# NTUA Headquarters Complex Office Building

Dyron Murphy Architects Project No. 2015.05

## ADDENDUM No. 1

October 27, 2016

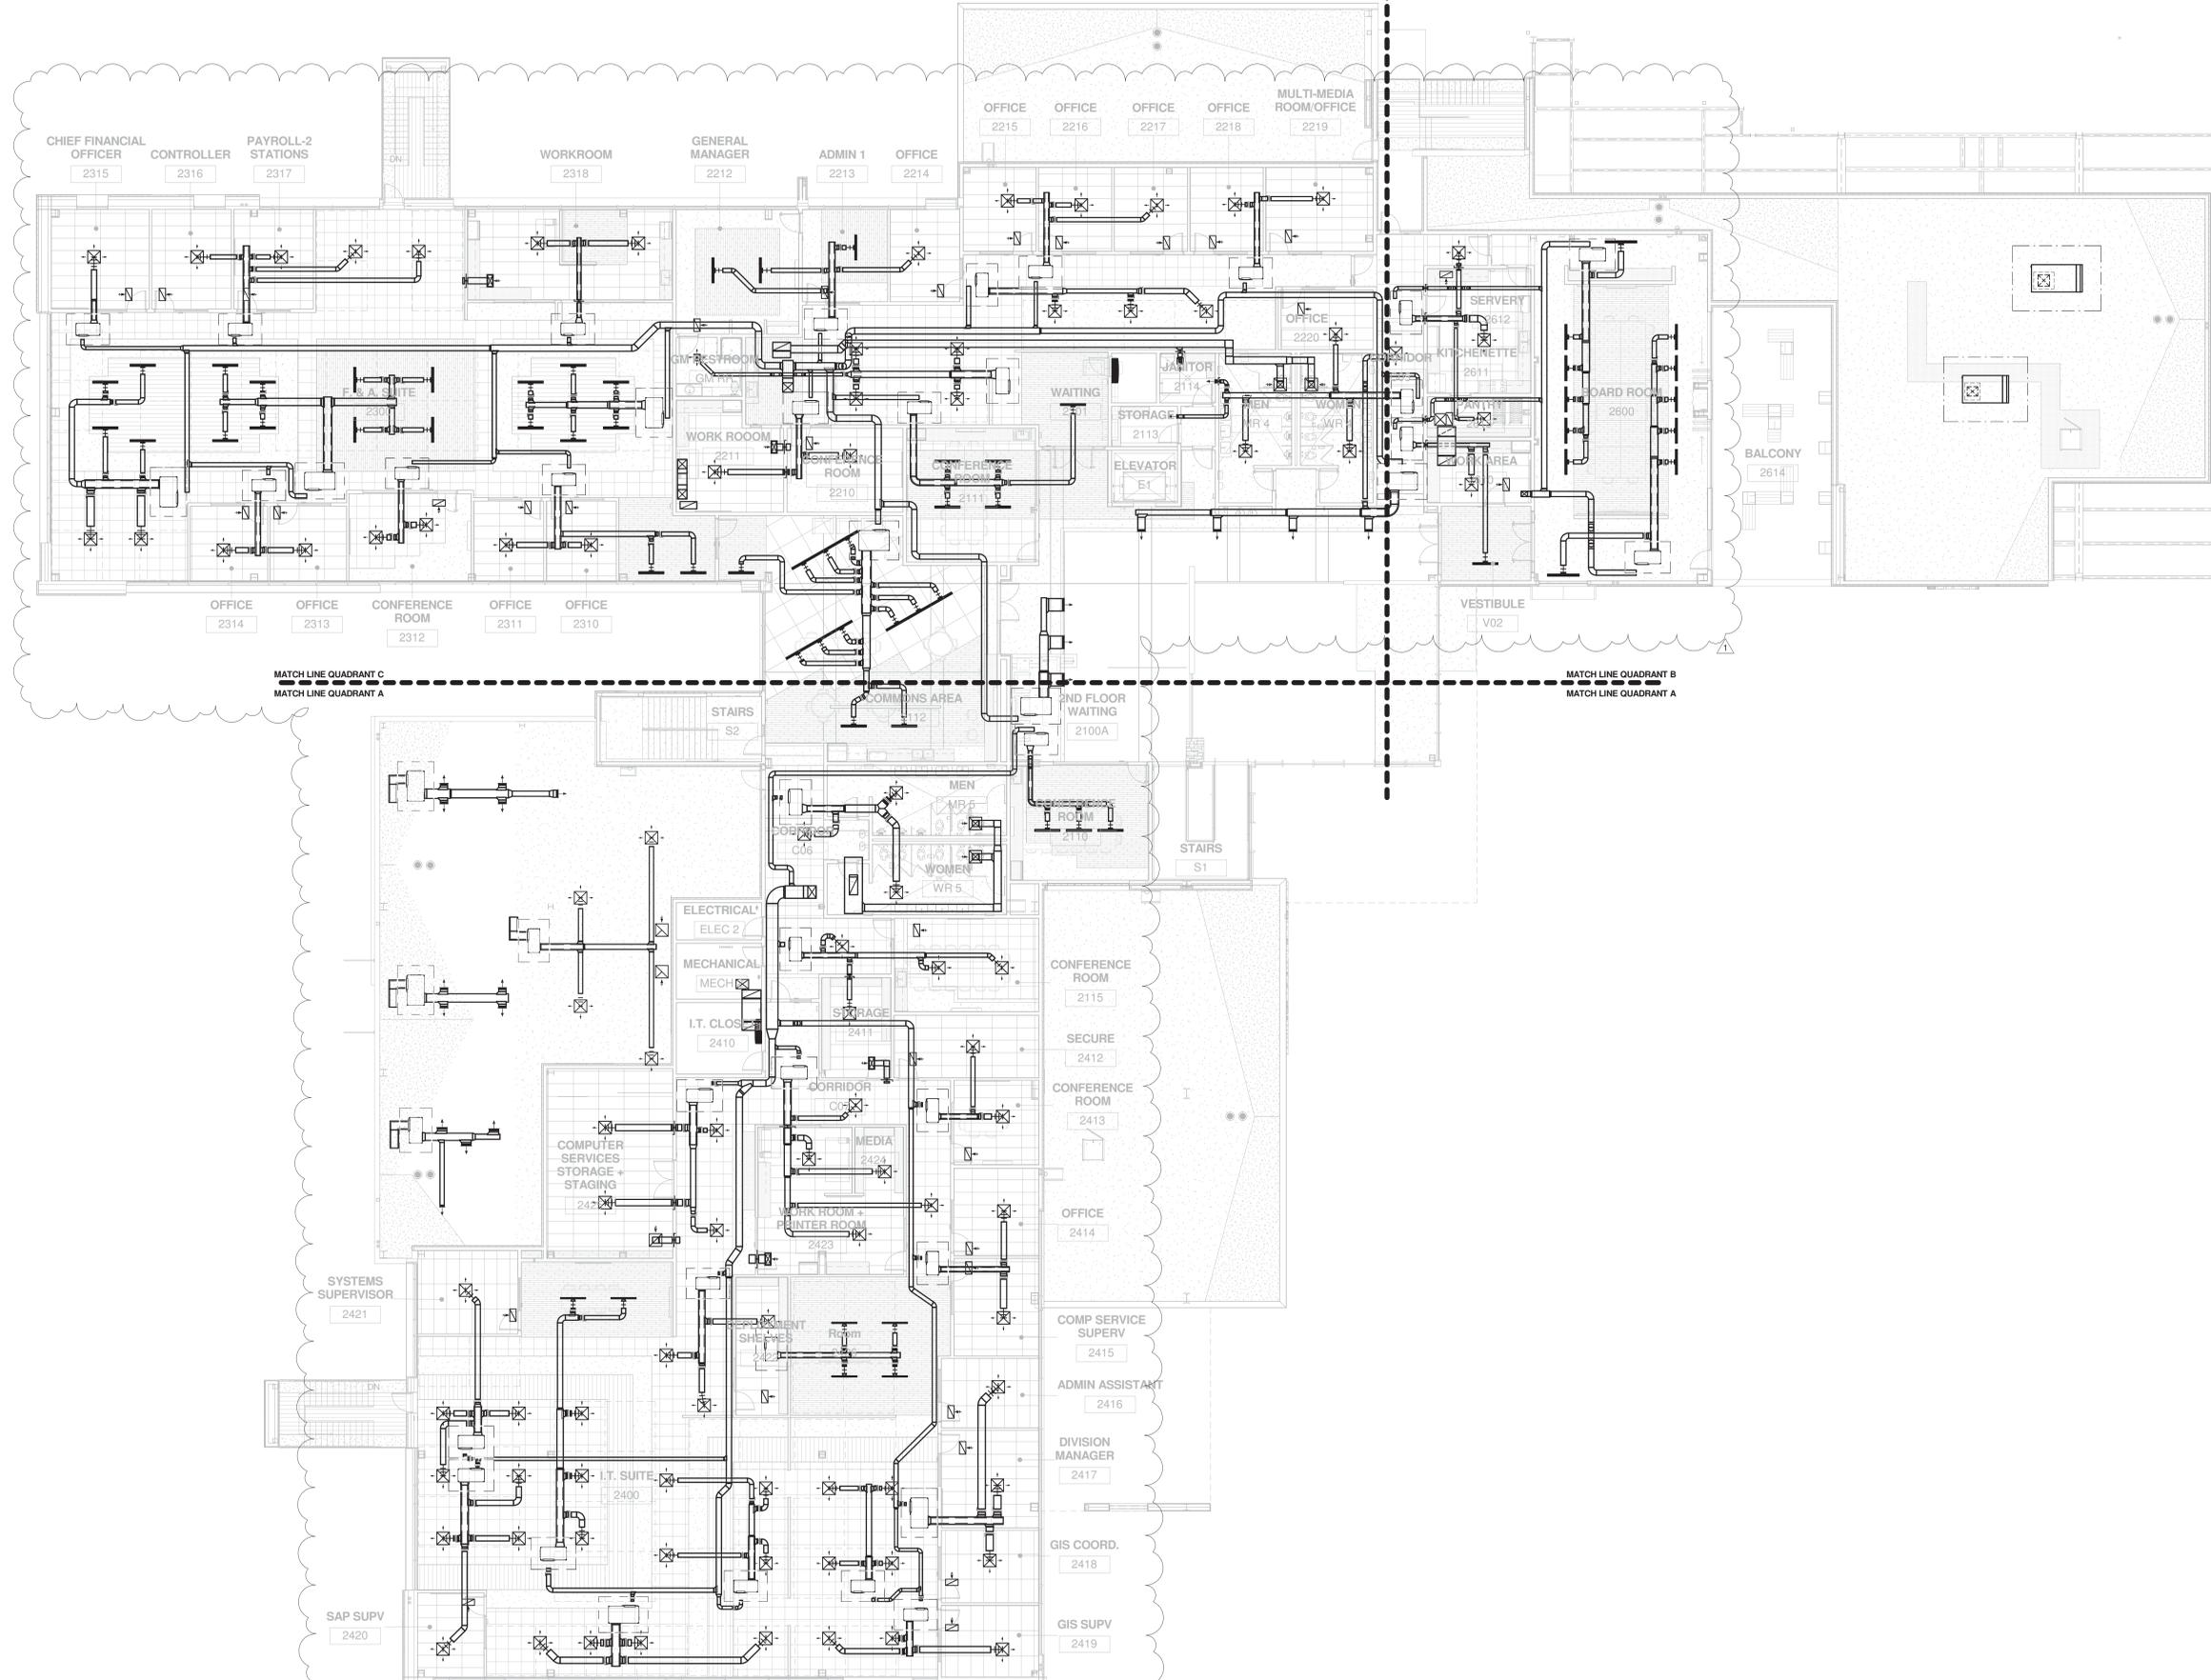
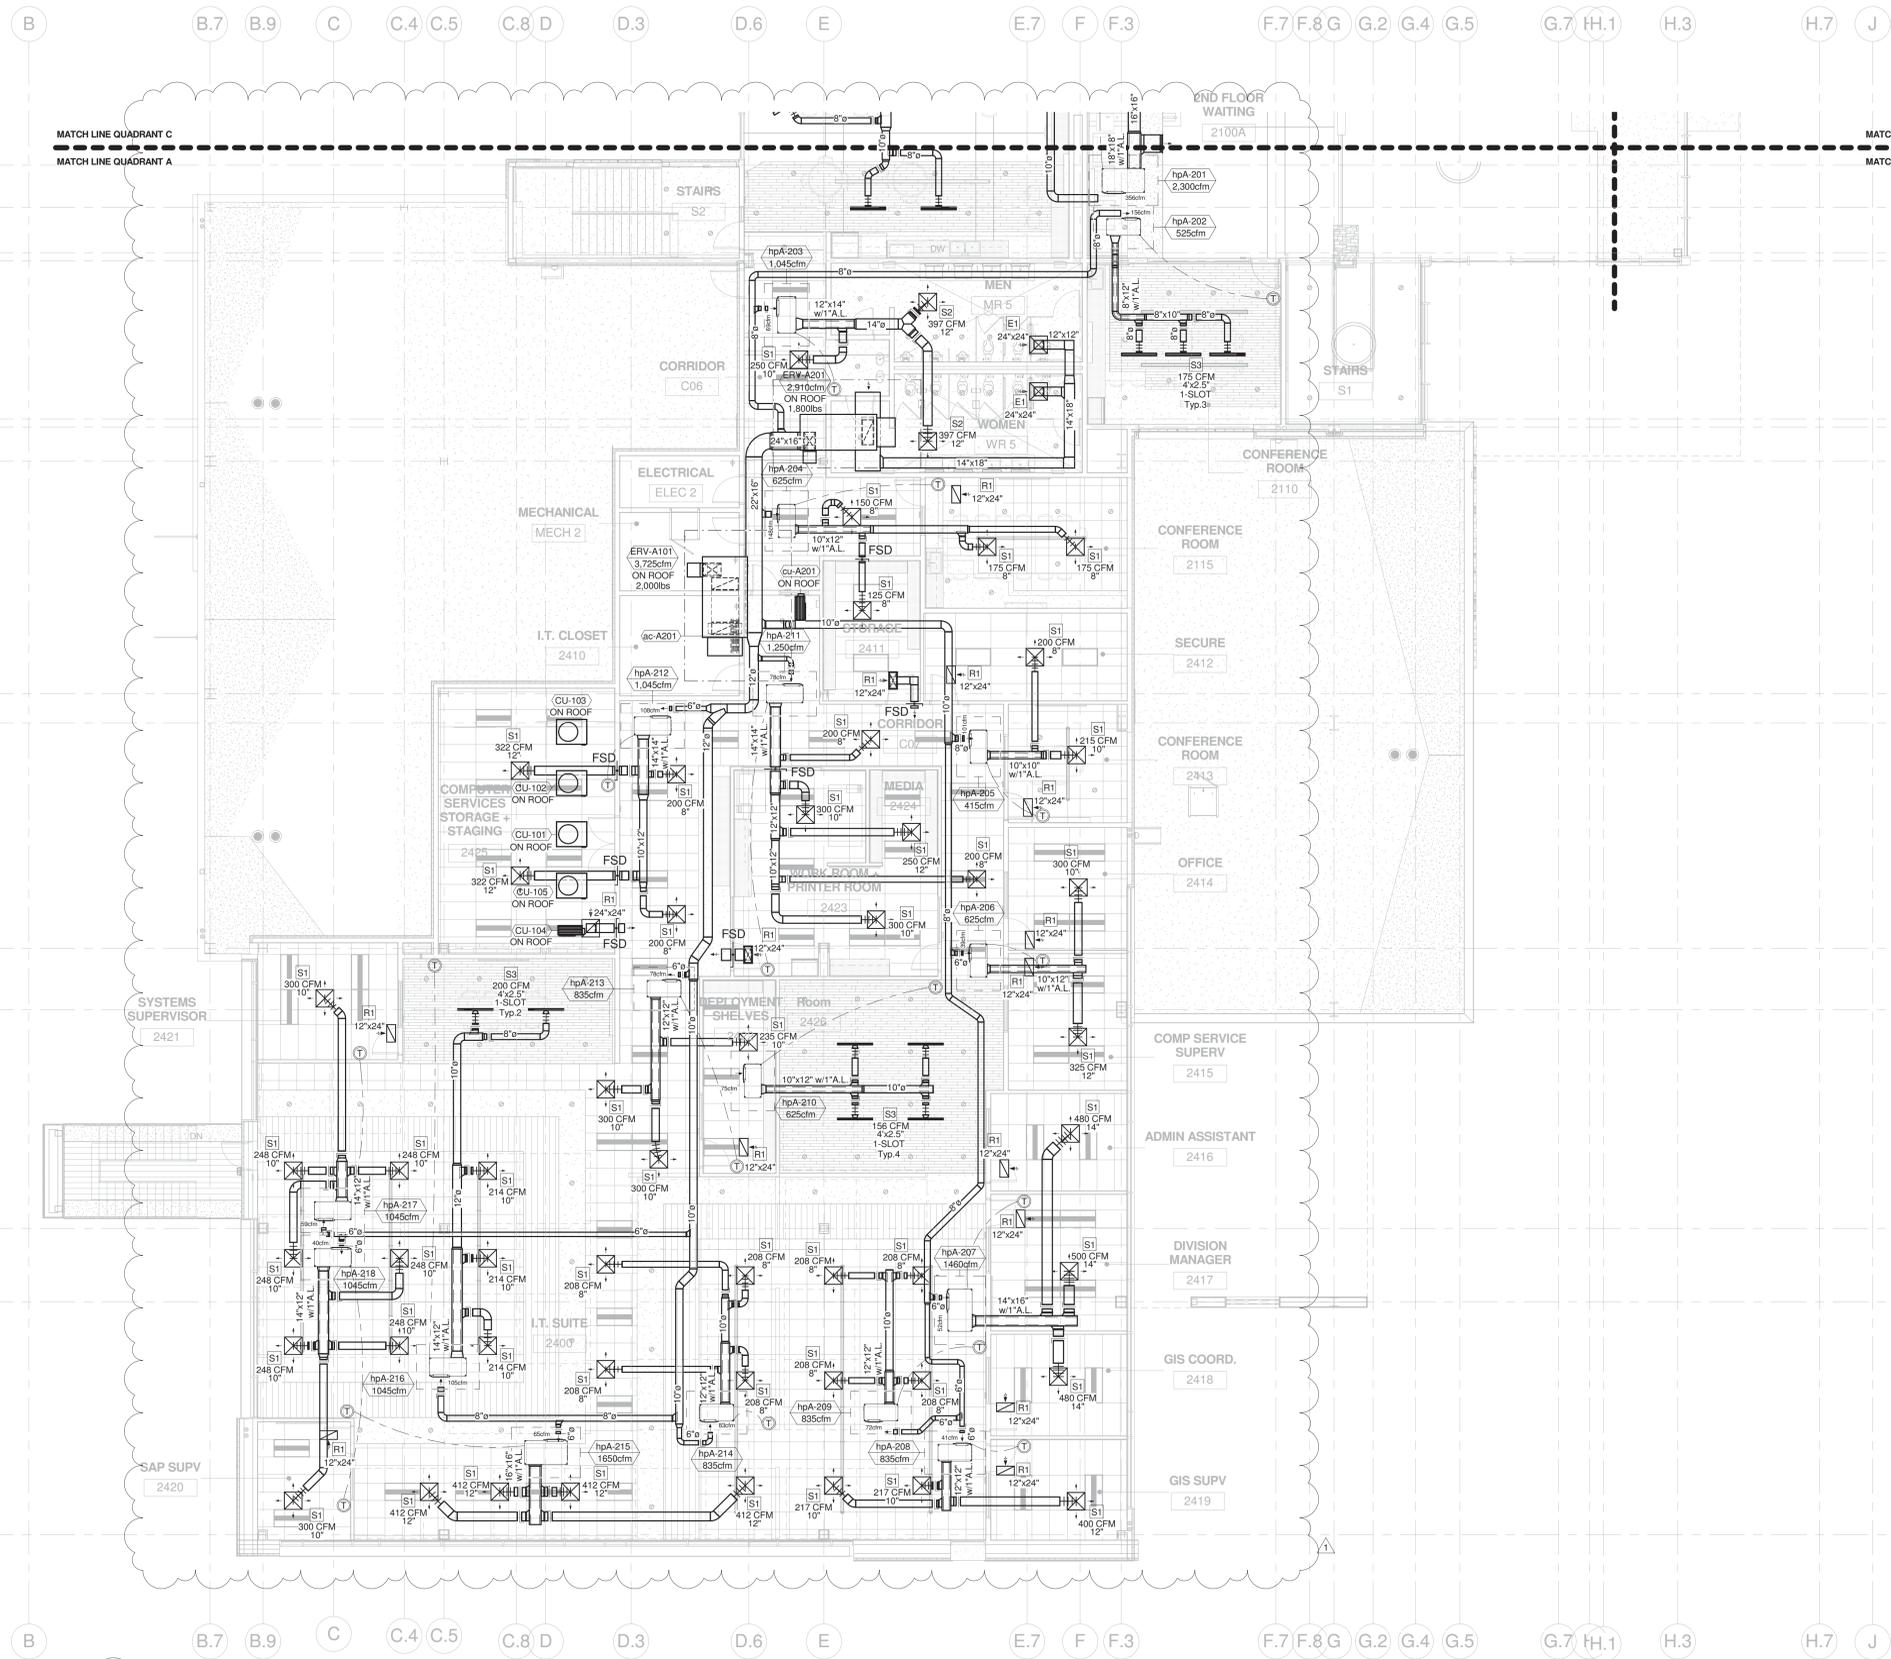
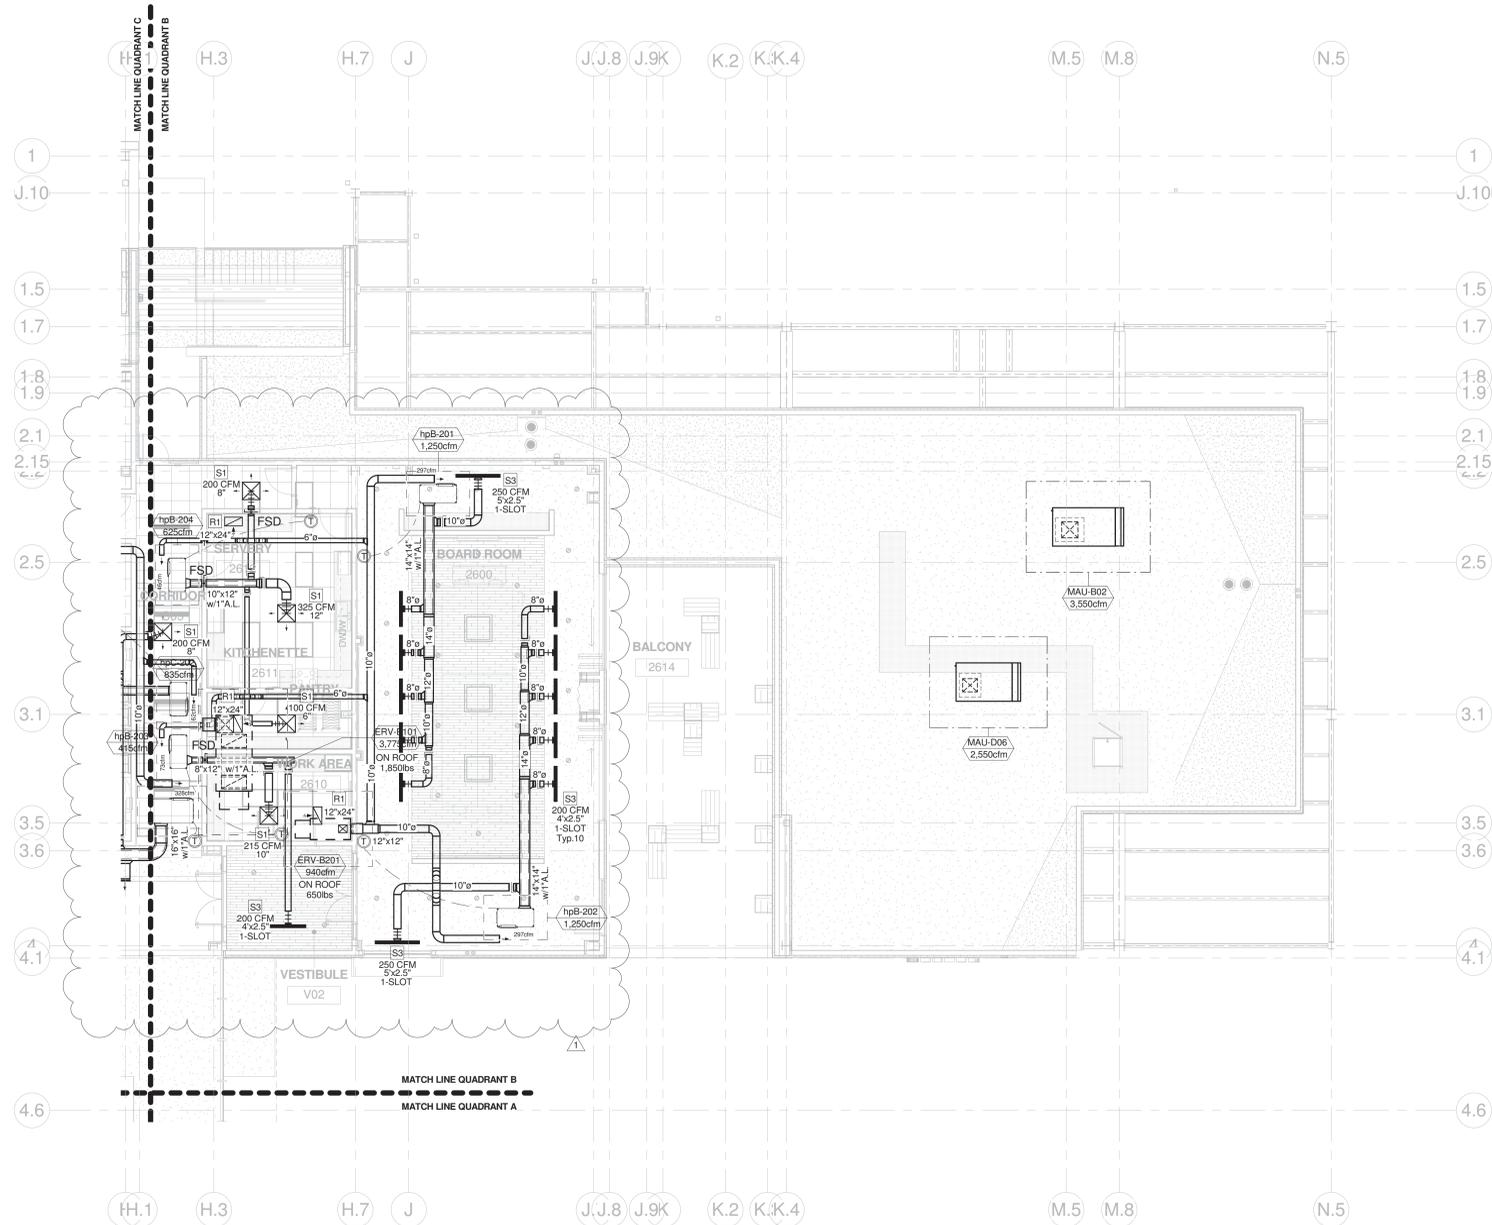
Drawing M102 MECHANICAL OVERALL 2 <sup>nd</sup> FLOOR HVAC PLAN	- REVISES: Outdoor Air Ventilation ductwork sizes & cfm capacities.
Drawing M102a MECHANICAL 2 <sup>nd</sup> FLOOR HVAC PLAN – QUADRANT A	- REVISES: Outdoor Air Ventilation ductwork sizes & cfm capacities.
Drawing M102b MECHANICAL 2 <sup>nd</sup> FLOOR HVAC PLAN – QUADRANT B	- REVISES: Outdoor Air Ventilation ductwork sizes & cfm capacities.
Drawing M102c MECHANICAL 2 <sup>nd</sup> FLOOR HVAC PLAN – QUADRANT C	- REVISES: Outdoor Air Ventilation ductwork sizes & cfm capacities. Supply Air ductwork and Diffuser locations in Board Room.
Drawing P305 PLUMBING WASTE & VENT RISER ISOMETRICS	- ENTIRE SHEET IS ADDED TO CONTRACT DOCUMENTS
